Subject: Change In Project Design, New Brine Return Pipeline Alignment
Palomar Energy, LLC (01-AFC-24)

Palomar Energy, LLC (PE) is filing this notice of a minor change to the Palomar Energy Project design. This change relates to the alignment of a portion of the project's brine return pipeline. This re-alignment will not result in the need to change any of the conditions of certification for the project.

Drawing showing overview of Brine Return and Reclaim Water Supply pipeline routes.

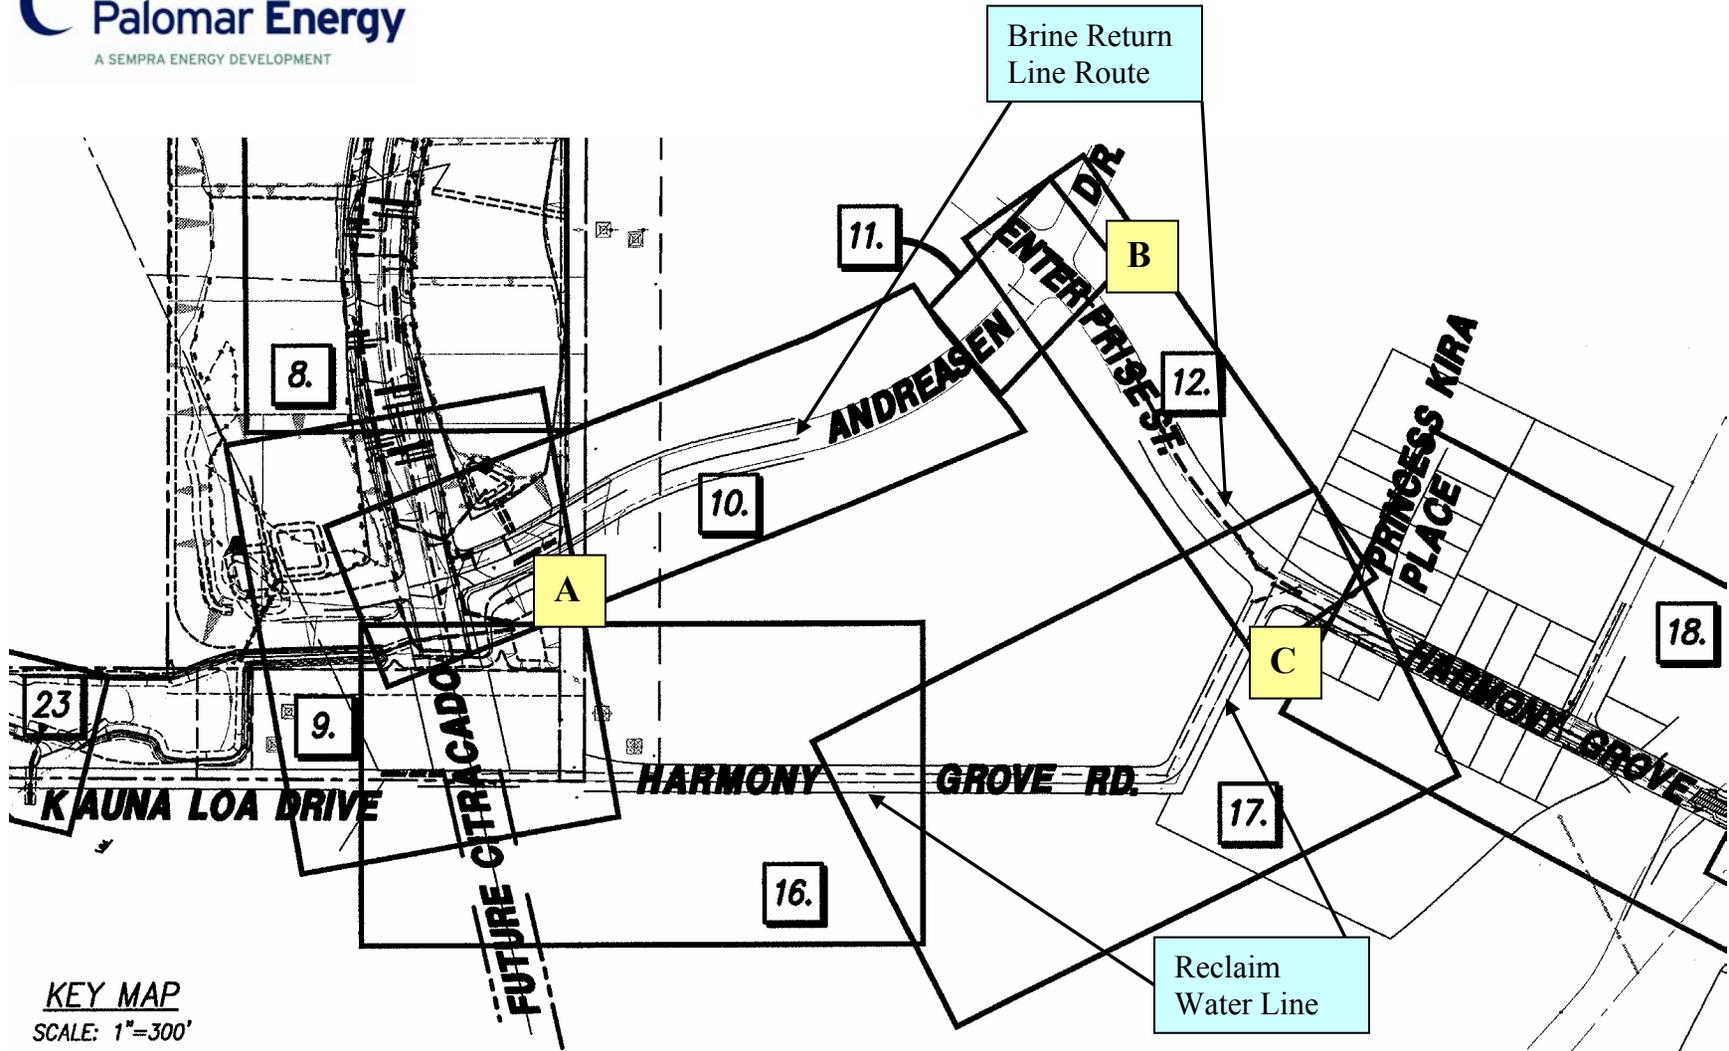
The PEP application for certification and Commission final decision describe the alignment of both the reclaim water supply and brine return pipelines being located within Harmony Grove Road. Since the Commission's decision was issued and during design review with the City of Escondido, the pipeline engineers discovered that in order to comply with County and State Health Department separation criteria (10 feet) between domestic water and the brine return (which is treated as sewer), the brine return line needs to be moved to a location within Andreasen and Enterprise streets (see attached figure). Therefore, a design change is necessary for a portion of the brine return line routing. The drawings showing the new location of this portion of the brine return line have previously been reviewed by the County Health Department, local municipal water district (Rincon del Diablo), and City of Escondido Public Works Department and final approval by the City is pending. Final approved drawings will be submitted to the CBO upon receipt from the City. This necessary change was not known during the certification proceeding and was only discovered when detailed site engineering and reviews by local authorities were undertaken.

There is no significant difference between the original route and the revised route with regard to potential environmental impacts and effects upon the public or nearby property owners. Both routes called for ground disturbance to occur entirely within the existing streets. Pictures of the proposed new route are attached. The areas adjacent to the new route consist of developed commercial and office buildings. There are no unique biological, cultural, water quality, or other impacts which are not already addressed in the existing license conditions. Reports of surveys of the new route by cultural resource and biological resource specialists were previously submitted to you. The new route is also included in the SWPPP for the project which has also been submitted to you. Because this relatively minor rerouting is very similar in its extent and effects
